RE: MP 08_0250 MOD 1 – Modification to Project Application- Hunter Medical Research Institute (Part3AMod)

HMRI Responses to Newcastle City Council comments 3 to 8 for consideration by the NSW Department of Planning and Environment – Modification Assessments.

Fig 1: Plan of Subdivision Document Ref CRH12-354C_DP_2A.pdf. This extract from the plan of subdivision whilst not appended to the NCC comments, has been included to aid in understanding of the ZHMRI response to the comment.

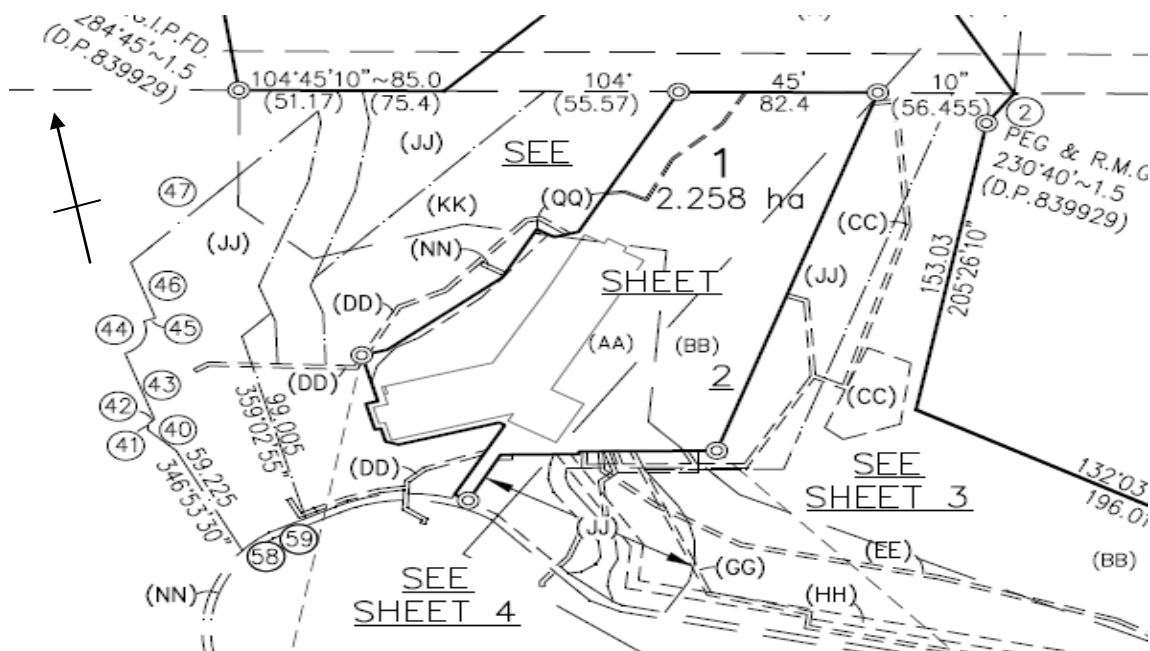
Comment 5 – That part of the land shown burdened by easement (JJ) Outer Protection Zone to the east of proposed Lot 1 should be notated as (KK) Inner Protection Zone is ^(sic) to comply with the Statement of Commitment 7.4 Bushfire – Recommendation 2 (See Appendix B of the Project Approval)

HMRI Response – Agreed. As previously discussed per comment 3, this is an error which the Surveyor has agreed to correct before resubmitting the revised plans of subdivision.

Fig 2: Extract Plan of Defendable Spaces (Inner Protection Zones) and Fuel Managed Areas (Outer Protection Zones) per ABPP Bushfire Protection Assessment for the Construction of the HMRI Building per ABPP Assessment Report No. B08900 dated 18/08/2009.

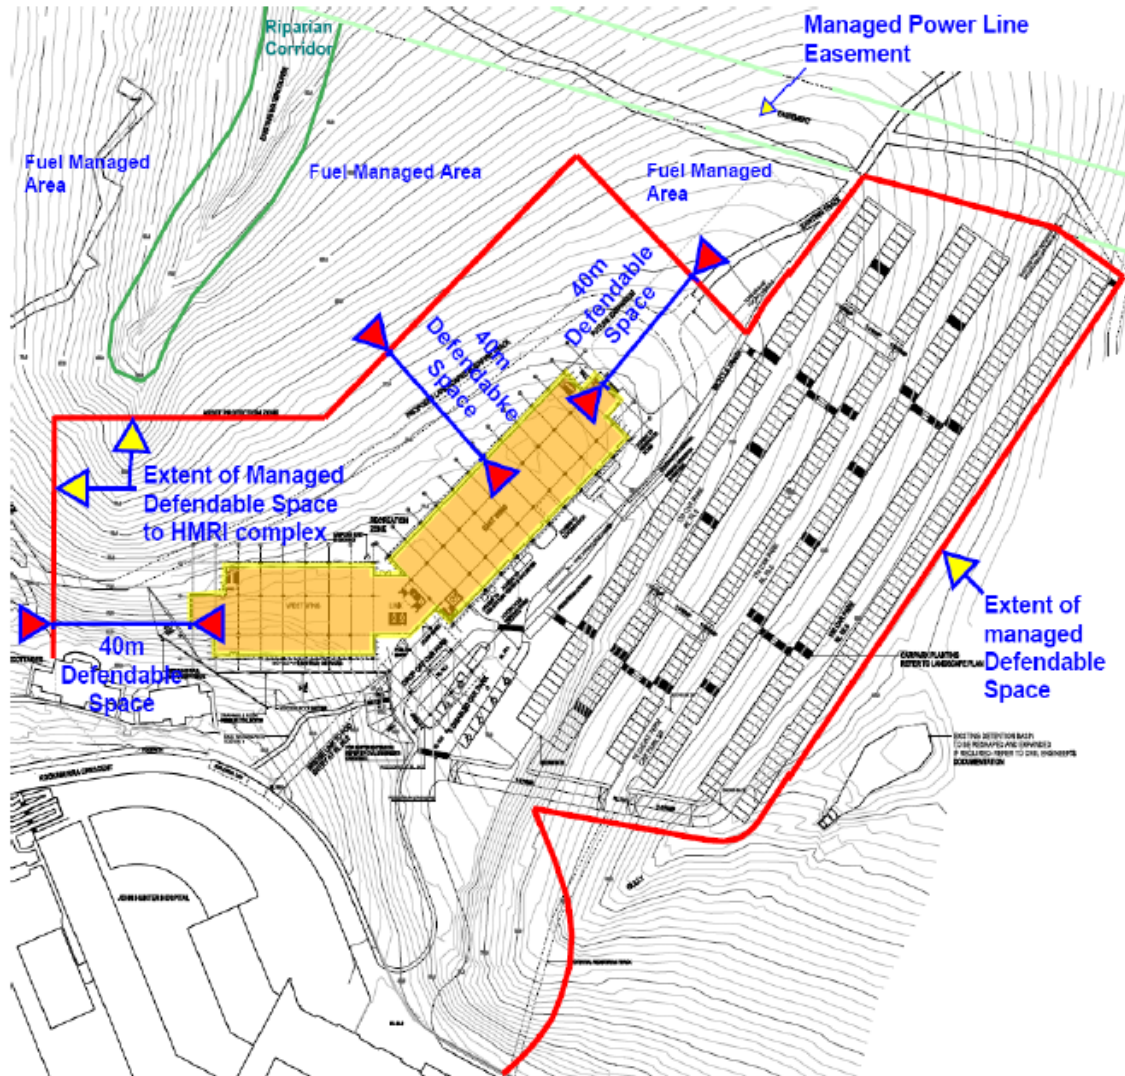
Comment 6 – The extents of (KK) and (JJ) to the west of the HMRI building are different respectively, to that shown as the defendable space and Fuel Managed Area in the Bushfire Protection Assessment by ABPP Ref. BO8900-2 dated 18 August 2009)

HMRI Response – Agreed. The basis for the irregularity in the harmonisation of the plan of subdivision and the Bush Fire Protection assessments are founded in three specific factors:

- The original Bushfire Protection Assessment B08900 dated 18/08/2013 was replaced when HMRI Built the Magnetic Resonance Imaging Centre onto the rear of the HMRI site in 2014 against Newcastle City Council Development Application 2013/0500 (consent granted on 25/07/2013) – See Fig. 2 (above)
- A new Bushfire Protection Assessment B131943 dated 1/5/2013 was produced see Fig. 3 (below) in support of this development (copy appended as a separate file to this

Fig 6. Conditions of Consent Drawing K1002 - key Drawing Access & Movement Pedestrian & Bicycle Movement

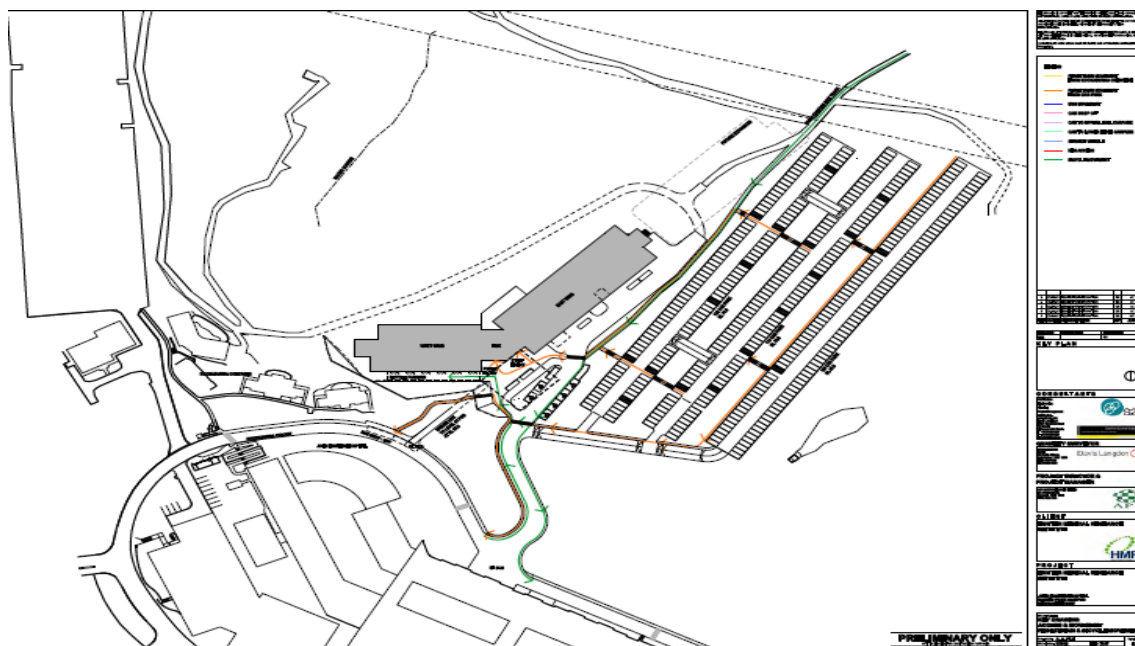
Comment 8 – The shared pathway entering proposed Lot 1 from the bushland to the North appears to be at least 2.5m wide, however proposed Easement (QQ) is noted as a Right of Footway 1m wide and variable. It is also apparent from arial photographs that the shared path provision extends further south than as depicted in the draft DP. The easement should be amended wholly to contain this pathway. Consideration should also be given as to who is to have benefit of this easement as members of the public might use this pathway to access the wider HNEH campus.

HMRI Comment – Agreed. NSW Government Department of Planning Document Ref : Determination of the Hunter Medical Research Institute Project – Major Project No. 08_0250, Schedule 2, Part A – Administrative Conditions Clause A2 states that “.. The Proponent shall carry out the project generally in accordance with the following plans documentation and recommendations ...” made therein:

Section (d) of the table referencing the aforementioned statement identifies a list of Architectural drawings which are to comply with the statement. Drawing K1002, Revision 5 Titled “Key Drawing Access & Movement Pedestrian & Bicycle Movement” dated 7/08/2009 and appended here below as Fig. 6, clearly supports a view that it was the intention of the Department when approving the development that there would be a direct linkage between the existing Jesmond shared bike and pedestrian Track and a path of travel through the HMRI site (see the green shaded flow through the drawing).

We note that the wording was listed as “generally in accord with” and to this extent, we have provided a secondary path of travel for push bikes through our site segregated from the pedestrian path. We did this as a result of a number of near misses with fast road racing push bikes being found to impact pedestrians. It is our view that this strategy works.

In Summary – We agree that there is a clear requirement to have a connected cycleway through the HMRI site and that this was always the intent of the conditions of consent. We propose that we will survey both the pedestrian path and the pushbike cycleway and provide easements for both in accord with the original intent of the Drawing K1002.
